DUKE POWER COMPANY
POWER BUILDING
422 SOUTH CHURCH STREET, CHARLOTTE, N. C. 28242

Reference: McGuire Nuclear Station
Units 1 and 2
Docket Nos. 50-369, 50-370

The purpose of Amendment 59 is to revise the FSAR to include the response to Mr. Robert L. Baer's letter of November 6, 1978 concerning the fuel building ventilation system. Also included in this amendment are descriptions of several design changes that have been made including:

DUKE POWER COMPANY
AMENDMENT NO. 59
APPLICATION FOR LICENSES
DOCKET NO. 50-369, -370

Figure 4.3.2-8

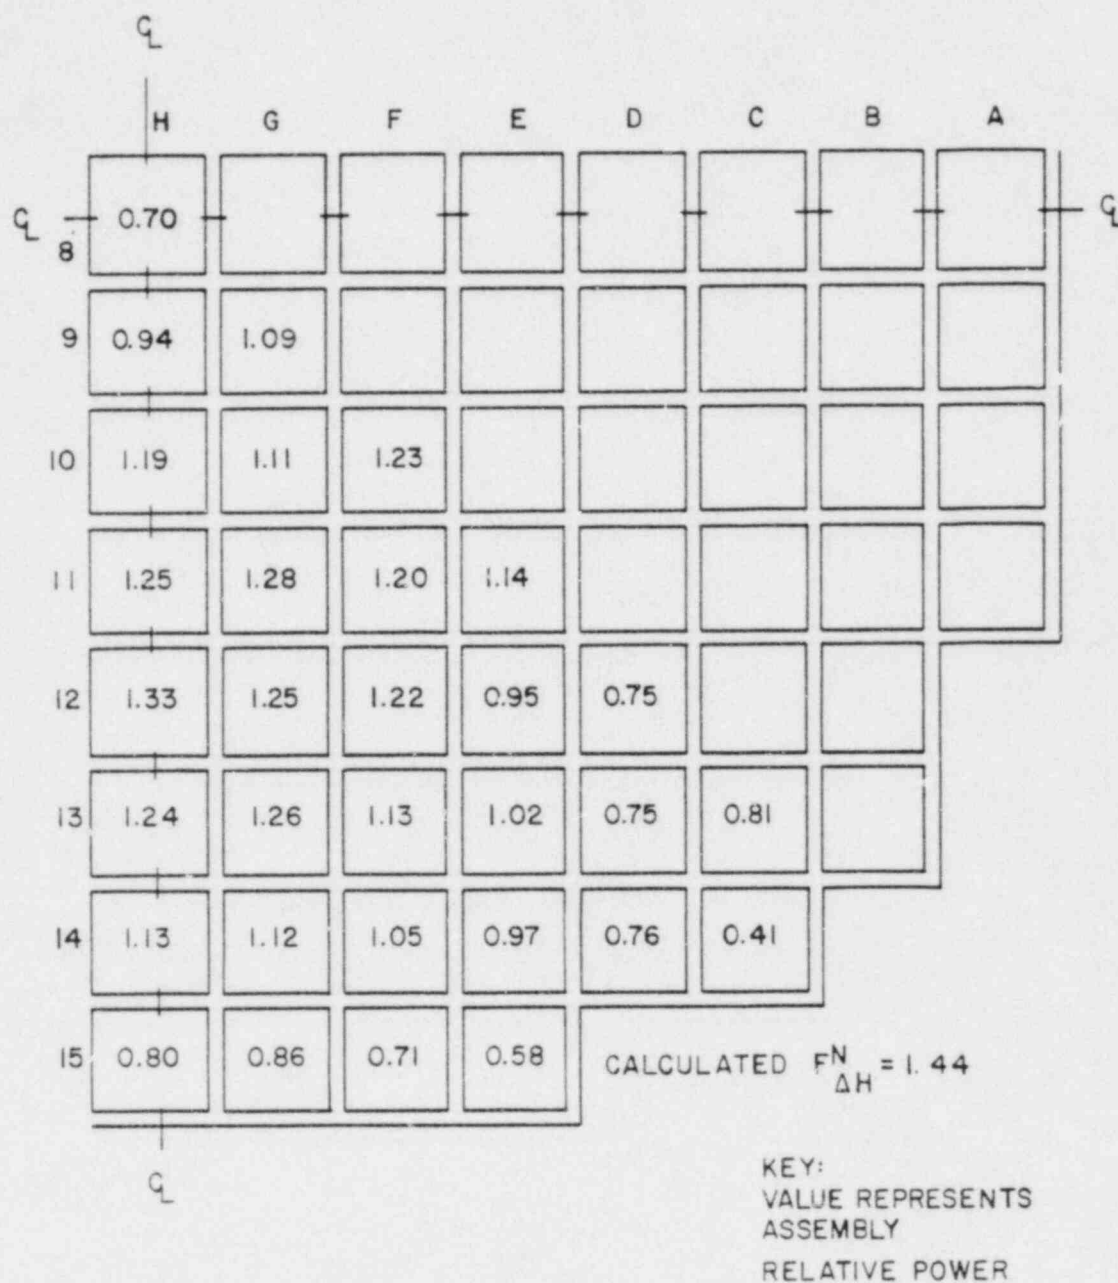
The radial power distributions shown in Figures 4.3.2-8 and 4.3.2-9 involving the partial insertion of control rods represent a synthesis of power shapes from the rodded and unrodded planes. The applicability of the separability assumption upon which this procedure is based is assured through extensive three-dimensional

NORMALIZED POWER DENSITY
DISTRIBUTION NEAR BEGINNING
OF LIFE, GROUP D 28% INSERTED,
HOT FULL POWER, EQUILIBRIUM XENON

Figure 4.3.2-36
Revision 3
New Figure

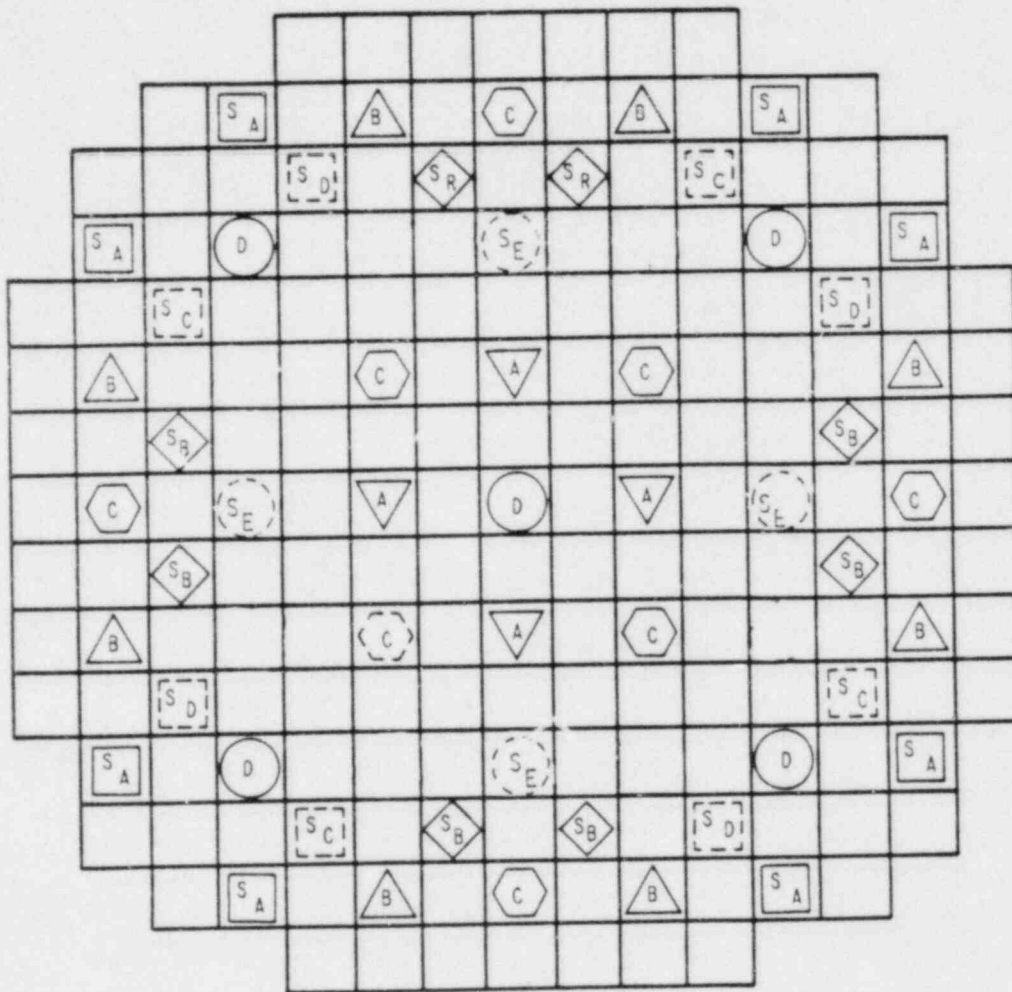
It becomes more negative with burnup reflecting the combined effect of moderator and fuel temperature coefficients with burnup. The power defect (integral reactivity effect) at BOL and EOL is given in Figure 4.3.2-36.

Figure 4.3.2-37
Revision 35

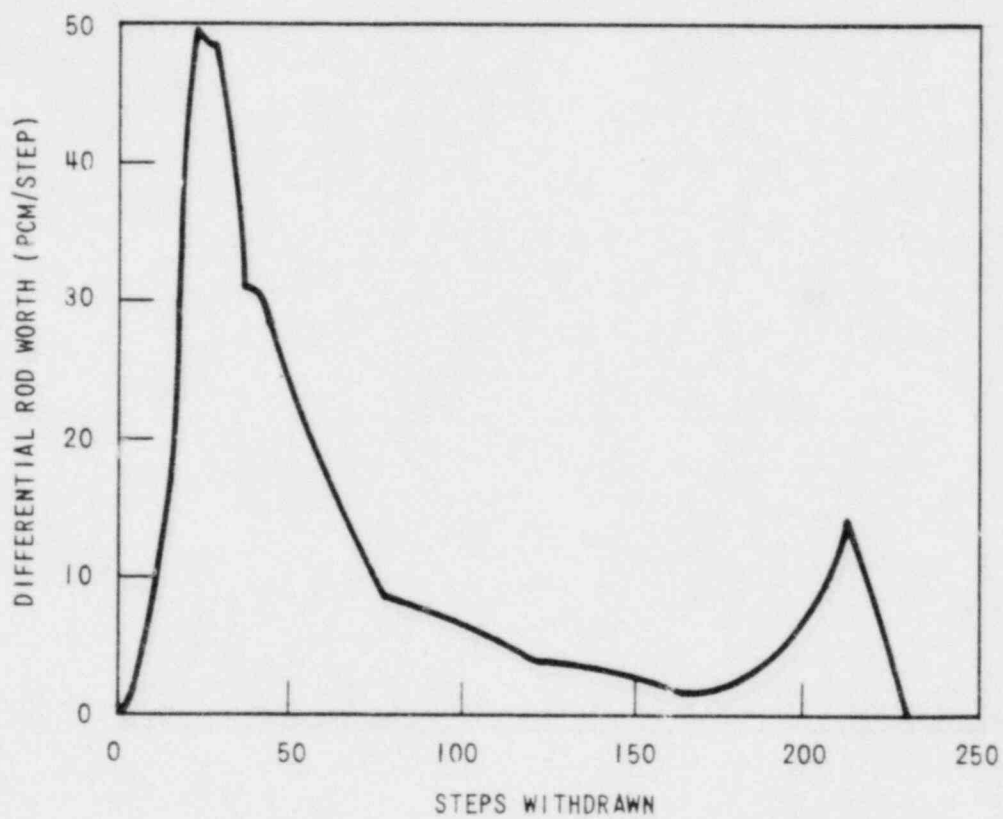
- 3 Power distribution, rod ejection and rod misalignment analyses are based on the arrangement of the shutdown and control groups of the rod cluster control assemblies shown in Figure 4.3.2-37. All shutdown rod cluster control assemblies are withdrawn before withdrawal of the control banks is initiated. In going from zero to 100 percent power, control banks A, B, C and D are withdrawn sequentially. The limits of rod positions and further discussion on the basis for rod insertion limits are provided in the Technical Specifications.

Figure 4.3.2-38
Revision 35

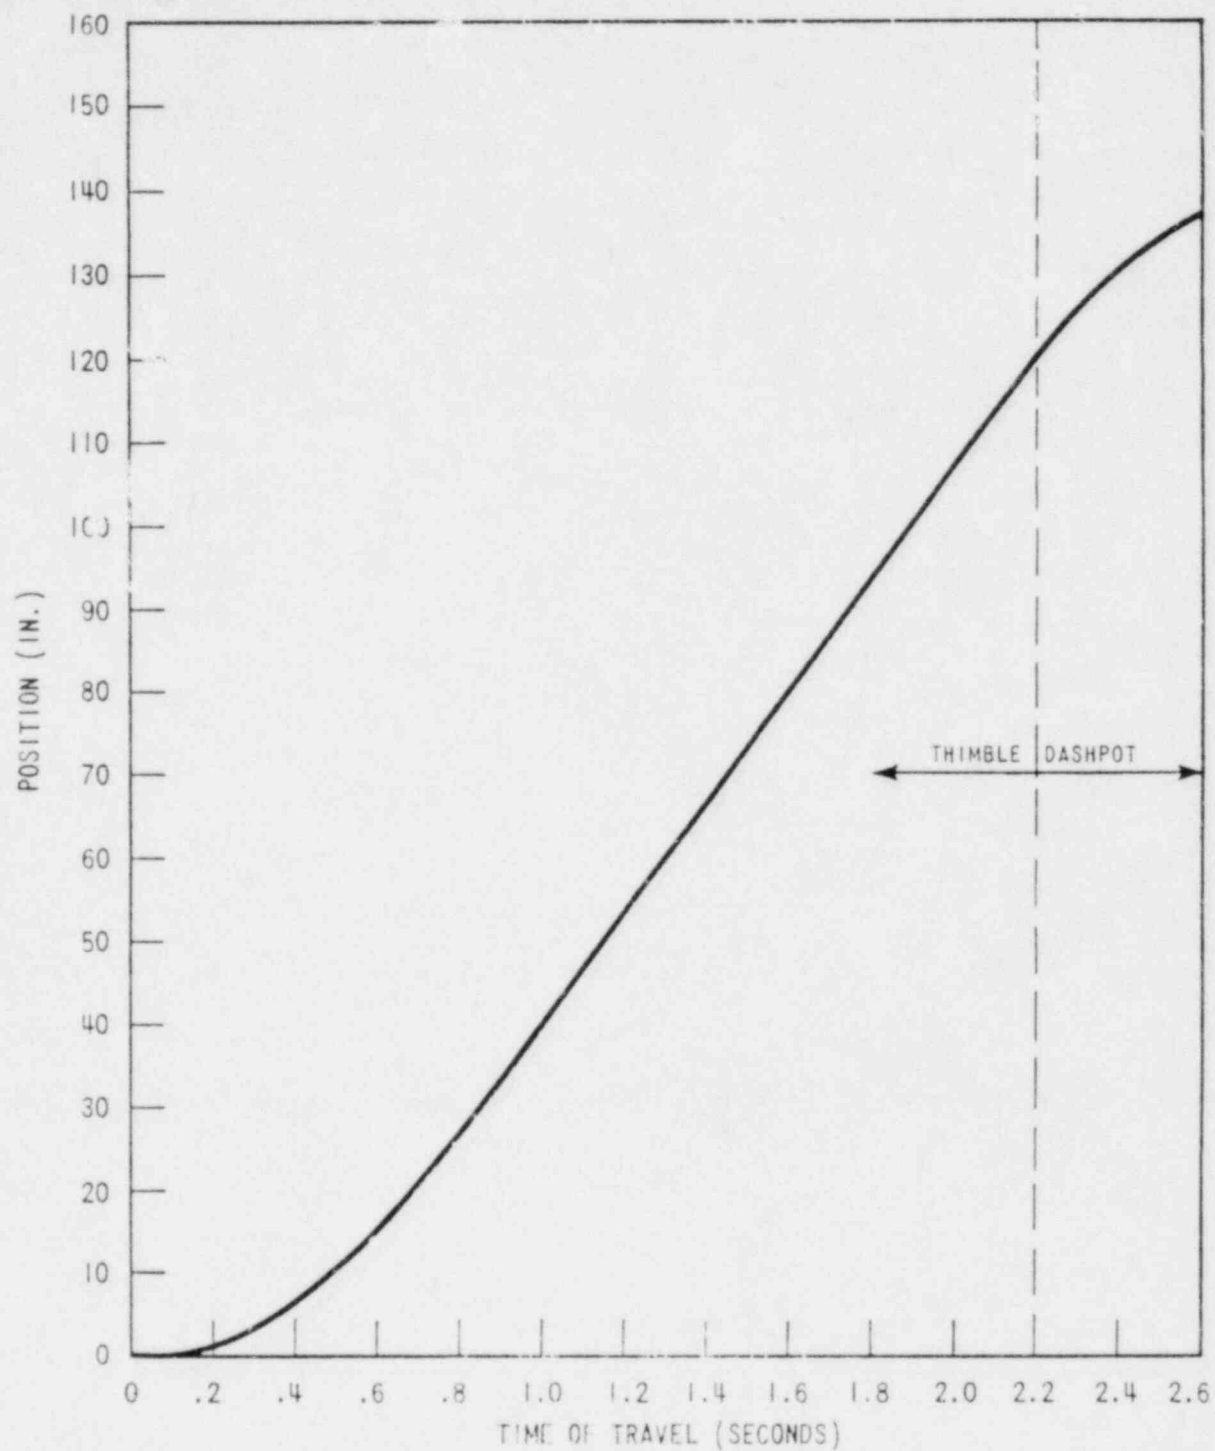
- 3 A representative calculation for two banks of control rods withdrawn simultaneously (rod withdrawal accident) is given in Figure 4.3.2-38.
